223 with 725.1 with ISA2 and M176 Harsh 3to4 Upshift

Topic number	LI27.60-P-080169
Version	2
Function group	27.60 - Gearshift, control
Date	7/22/26
Validity	BR223 with M176 engine and 725.1 (NAG3 Mopf) transmission with ISA2
Reason for change	Software release CW24 for some models

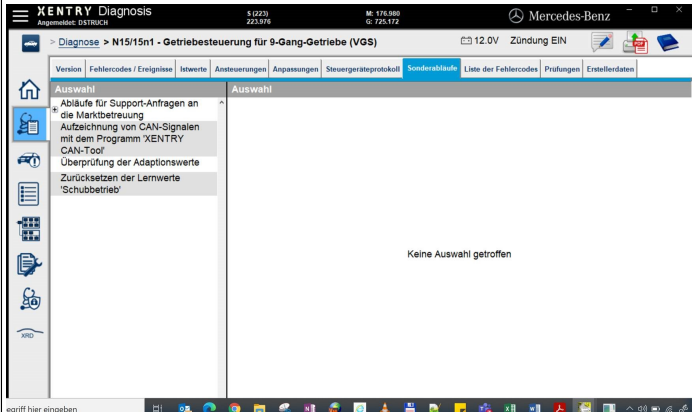
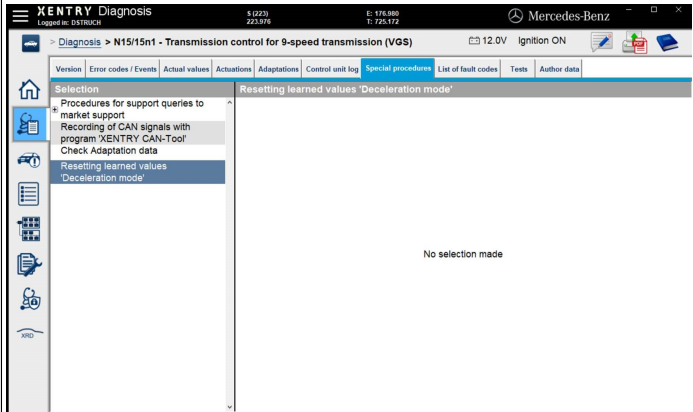
A software resolution has been released for several model years with software levels 22A.3 (n3g222aa03ub) and 22A.4 (n3g222aa04ub).

- Check VGS control unit log or eeprom .txt file for "Program Status" to determine your vehicle.
